"Low Engine Oil" Message

Service Category Engine/Hybrid System

Section Lubrication

Figure 1. Warning Message Under the Speedometer

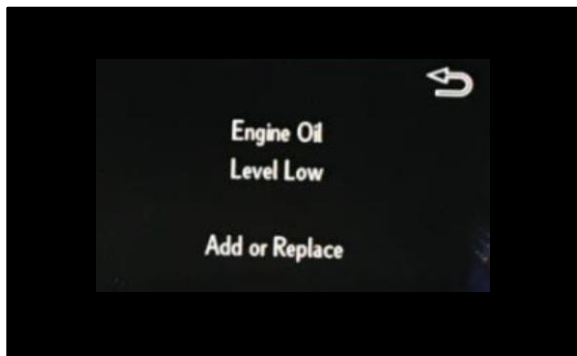
Some 2018 model year LS500 and LS500h vehicles may exhibit a warning message either under the speedometer ("Engine Oil Level Low Add or Replace") or on the Navigation screen ("Low Engine Oil"). Follow the Repair Procedure in this bulletin to address this condition.

4. Flash reprogram the combination meter ECU.

Follow the procedures outlined in Service Bulletin No. [L-SB-0001-18](#) "Techstream ECU Flash Reprogramming Procedure," and flash the combination meter ECU with the NEW calibration file update.
